Preferred Project Report

UTS City Campus, Broadway Precinct Concept Plan 08_0116

Submitted to
Department of Planning on Behalf of
the University of Technology Sydney

October 2009 ■ 08439

Figure 1 – 3D Model of building envelopes (Source: BVN, DCM and JBA)

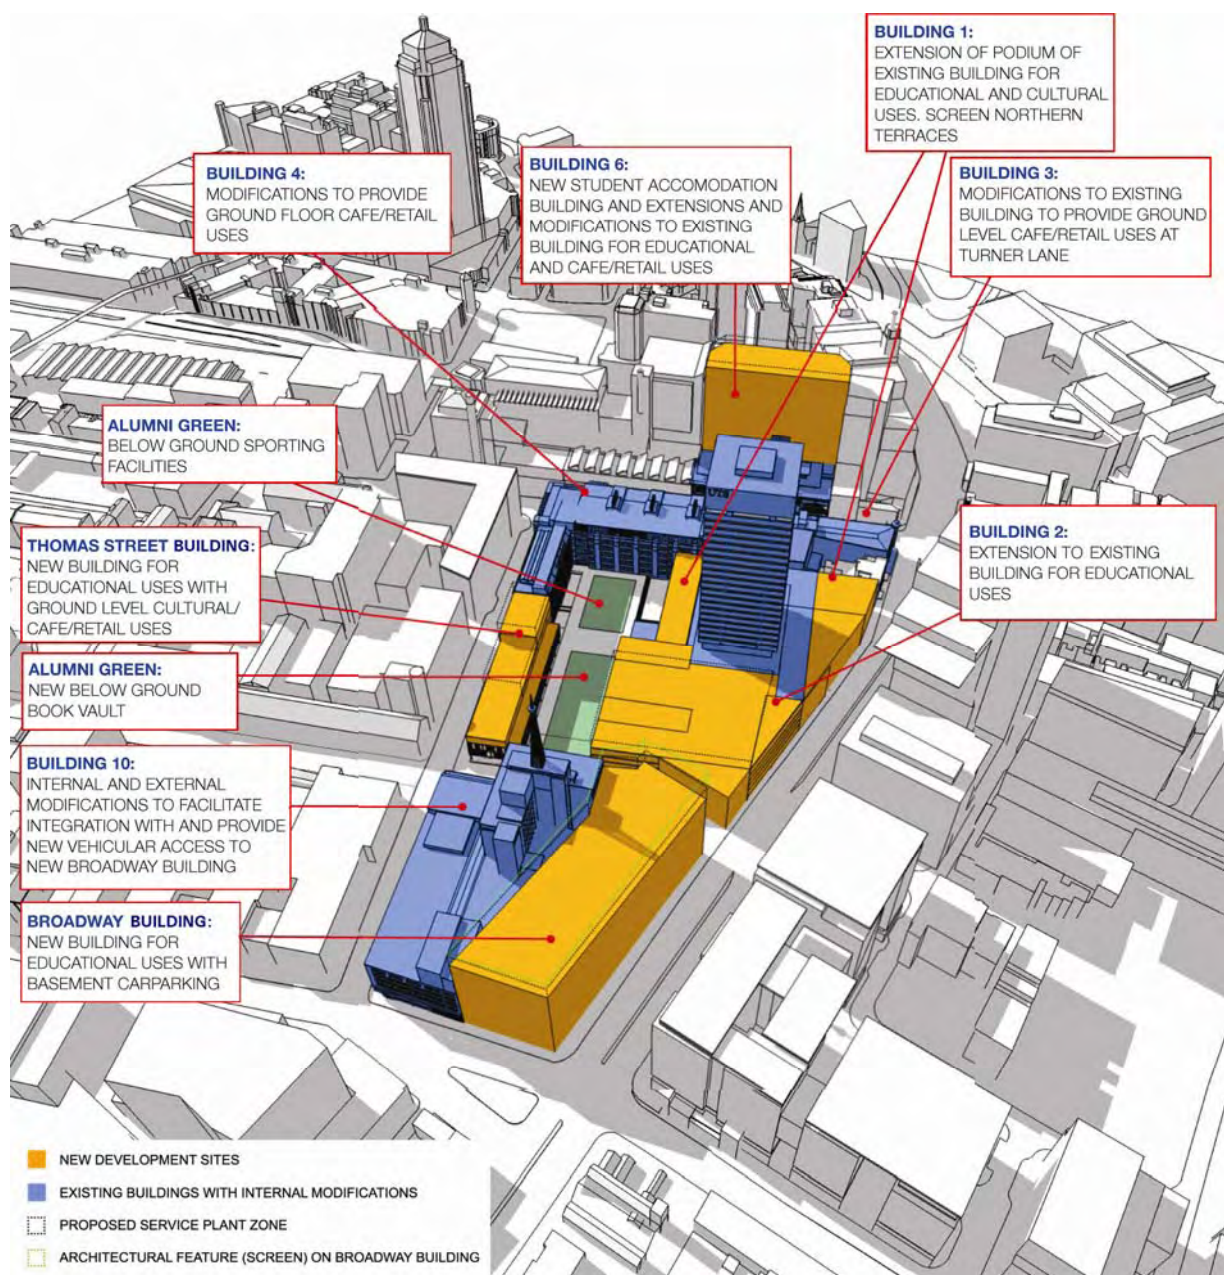
The architectural drawings of the revised building envelope and proposed architectural feature have been prepared by DCM and are attached as **Attachment 13** in Volume 2. **Figure 1** illustrates the revised 3-D model of the Concept Plan.

Figure 2 – Building envelope in relation to SLEP 2005 height limit (Source: BVN and DCM)

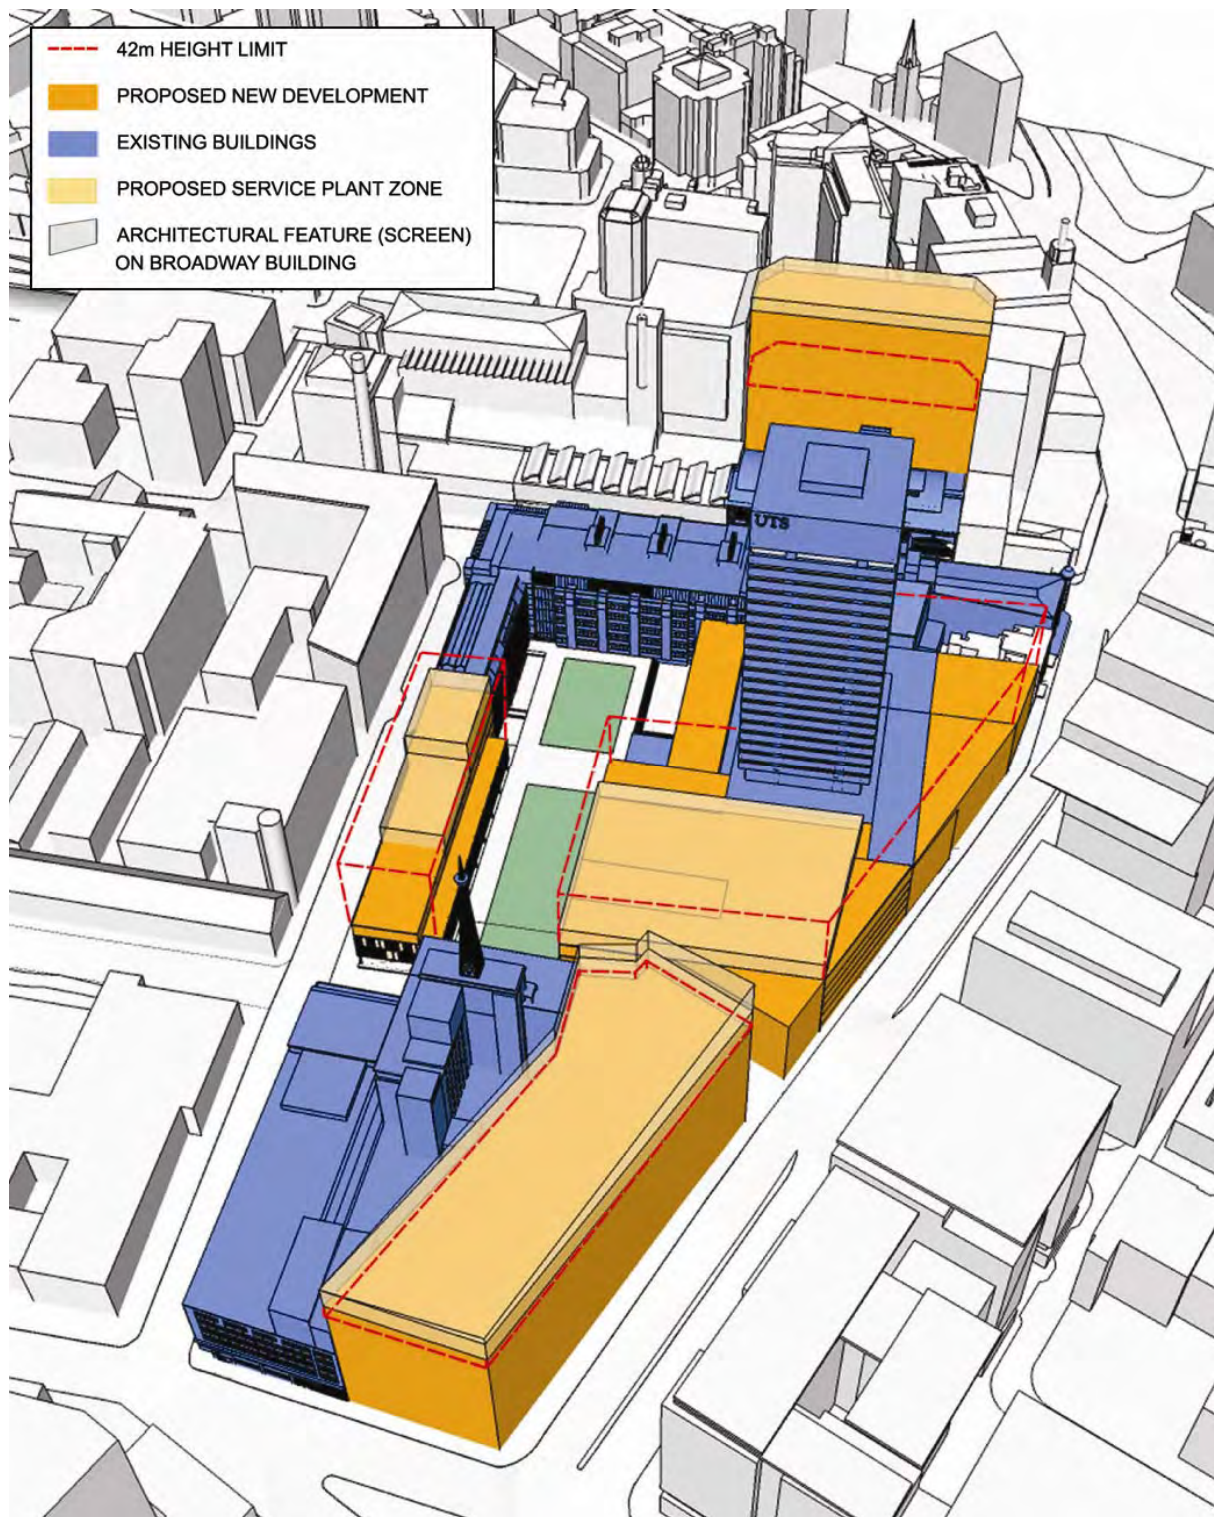
- The maximum height of the envelope (along Wattle Street) is increased by 0.67 metres to 46.91 metres (RL 54.64) as defined under Sydney Local Environmental Plan 2005 (SLEP 2005) or to 54.11 metres if measured in accordance with the Standard Instrument – Principal Local Environmental Plan (see **Figures 2 and 3**).

- The footprint of the building has been slightly altered to remove the overhang of Building 10 proposed in the Concept Plan (see **Figure 2**).

Figure 4 – Pedestrian circulation (Source; BVN and DCM)

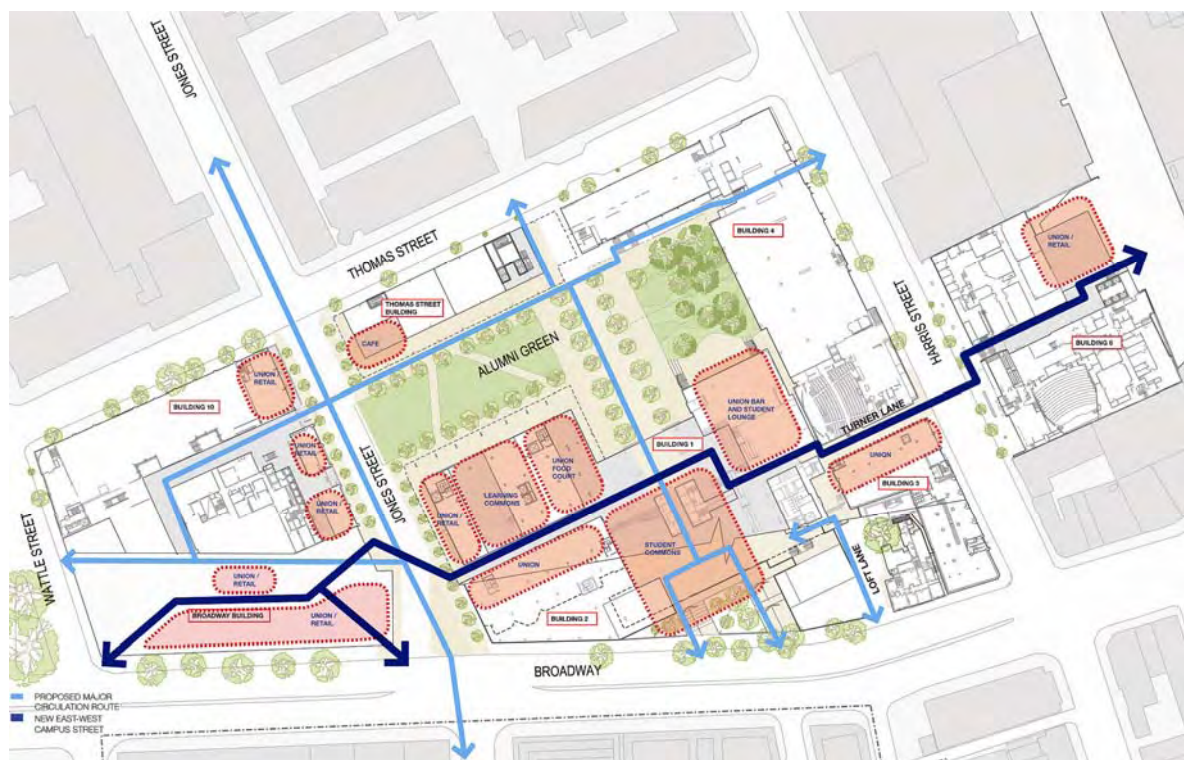
- Through-site connections have been increased with the addition of a pedestrian thoroughfare between Jones Street and the corner of Wattle Street and Broadway. This is in addition to the connection between Jones and Wattle Streets adjacent to Building 10 described in the EAR (see **Figure 4**).

Figure 6 – Broadway Building on Broadway at Wattle Street (Source: DCM)

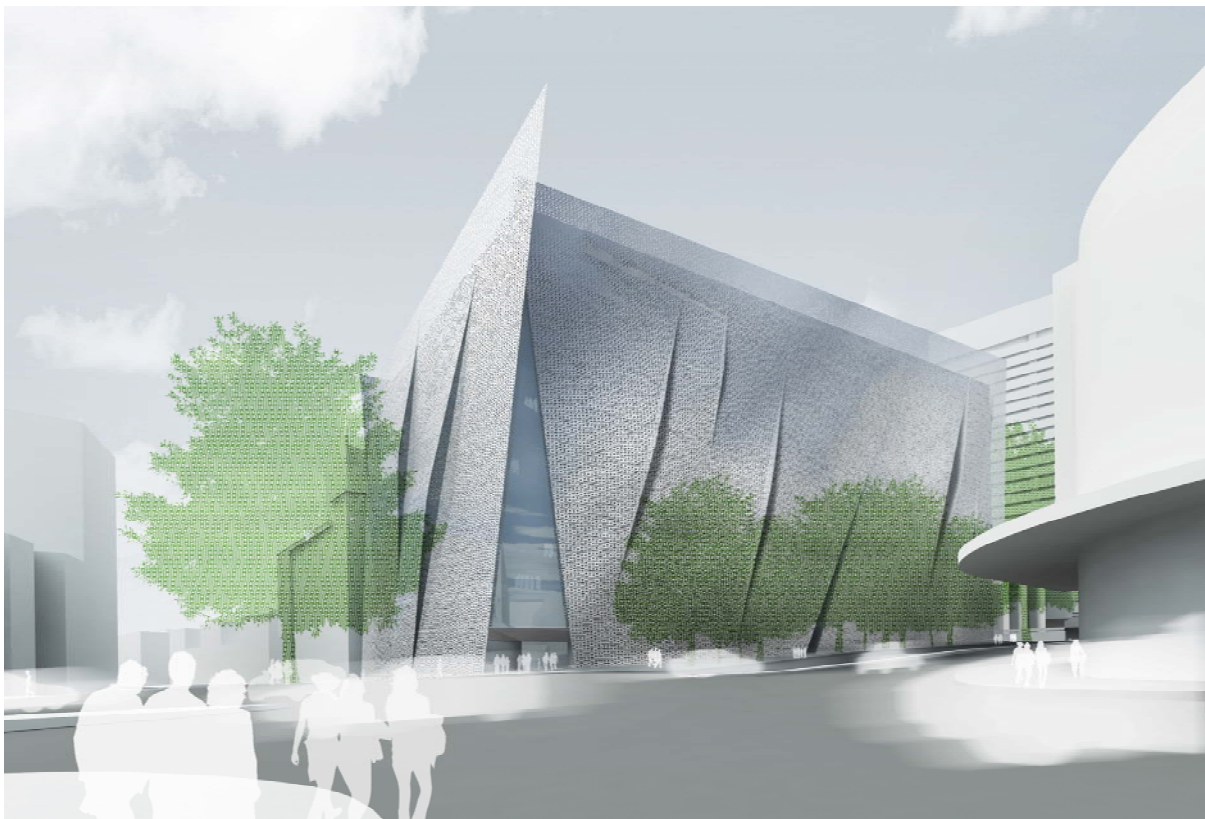
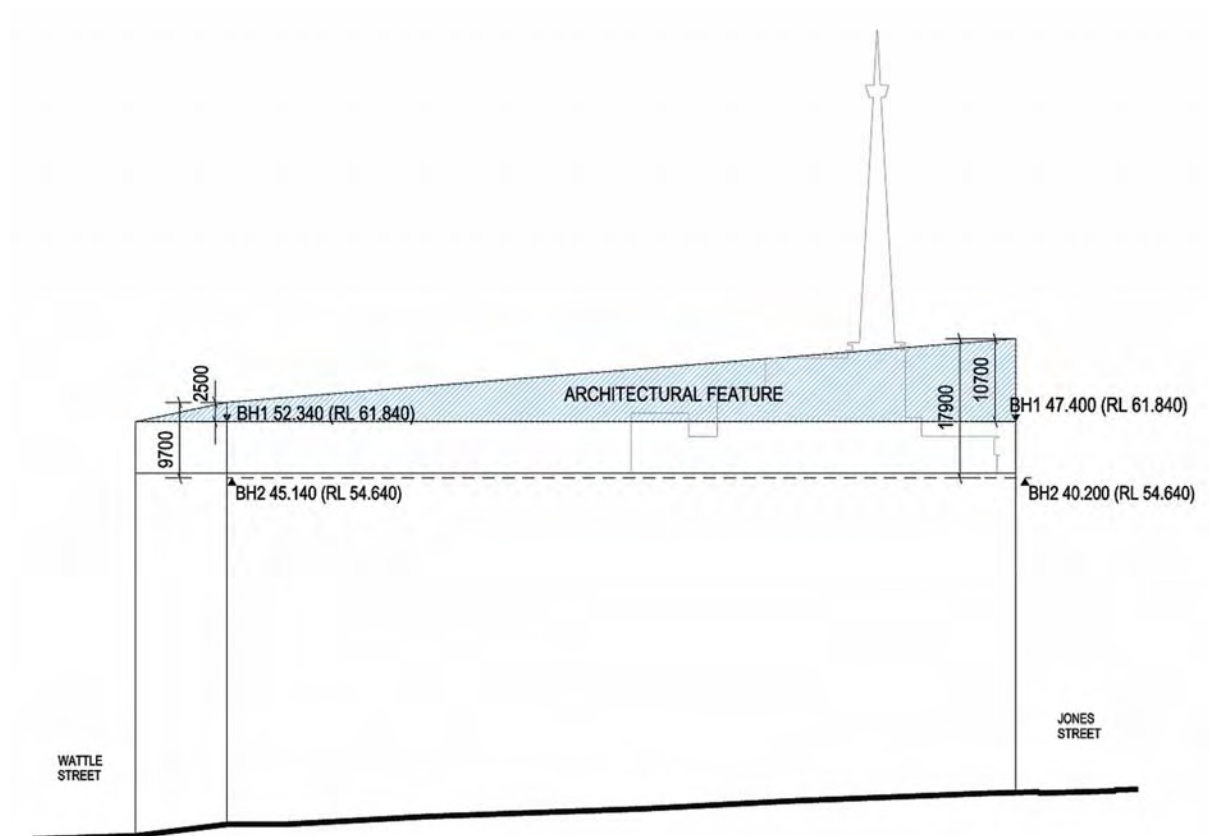
- The winning design incorporates an architectural feature in the form of four tilted and skewed perforated aluminium screens (plates) cladding the four facades of the building, illustrated at **Figures 5 and 6** and described in **Section 3.1.2** below.

As shown in the artist's impressions at **Figures 5 and 6**, the architectural feature is designed to allow the building to read as a single sculptural object with the floor levels concealed within its skin. As summarised in **Table 2** and illustrated at **Figures 7 to 10**, the feature will consist of four screens with a different profile on the four facades of the building. At its highest point on Broadway, the top of the feature will slope from 2.50 to 10.70 metres above the roof of the building (measured in accordance with the Standard Instrument).

Figure 12 – South elevation – Broadway (Source: BVN and DCM)

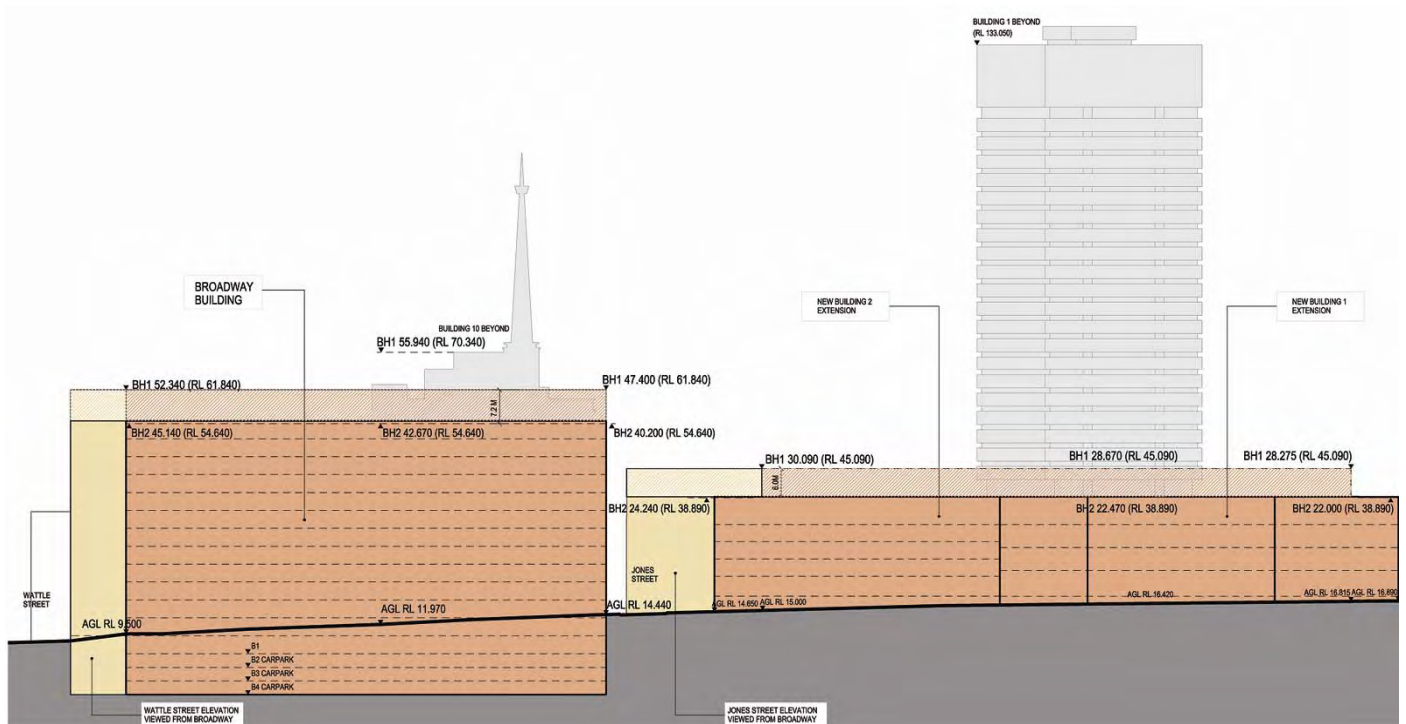
The revised envelope (without the architectural feature) remains below the maximum height of the Frasers development which ranges from 57.50 metres directly opposite the Broadway Building to 116.50 metres opposite Building 1. Elevations of the new envelope are illustrated in the drawings at **Attachment 13 of Volume 2** and reproduced in **Figures 12 and 13** below.
